MITSUBISHI MOTOR SALES OF AMERICA, Inc.

TECHNICAL SERVICE BULLETIN

VALVE BODY CHANGES IN KM170 SERIES TRANSAXLES

NO.	TSB-89-21-002
DATE	January, 1989
MODEL	Mirage, Galant

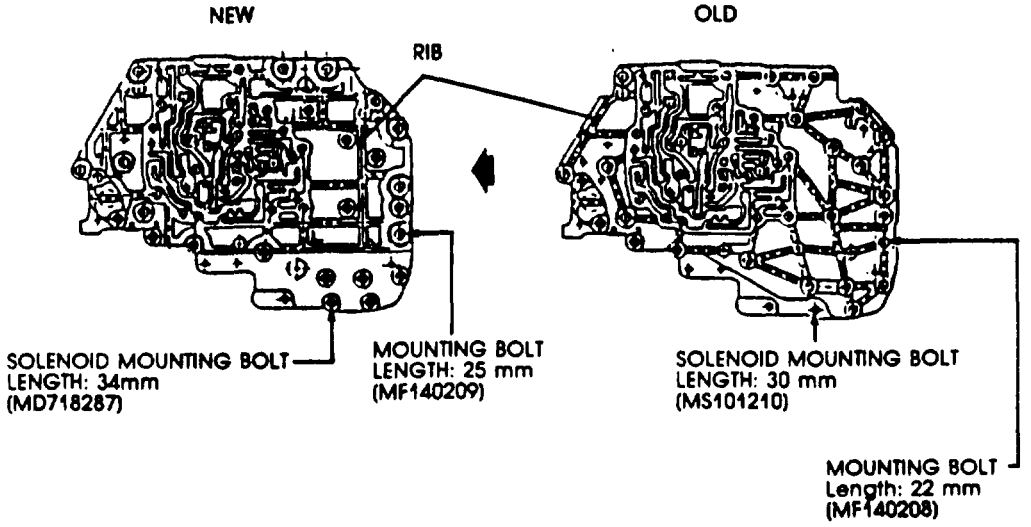
1. Intermediate Plate and Mounting Bolts
   On the KM175 transaxle the following changes have been made as shown:
   a. The intermediate plate ribs have been changed,
   b. The lengths of the valve body mounting bolts have been increased.
   c. The lengths of the solenoid valve mounting bolts have been increased.

New and old valve body and mounting bolts are interchangeable only as a set.

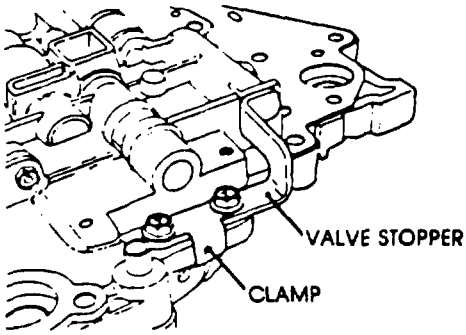
2. Wire Clamp
On the KM171 and KM175 the clamp used to route the so· ›id valve wires has been changed in shape.
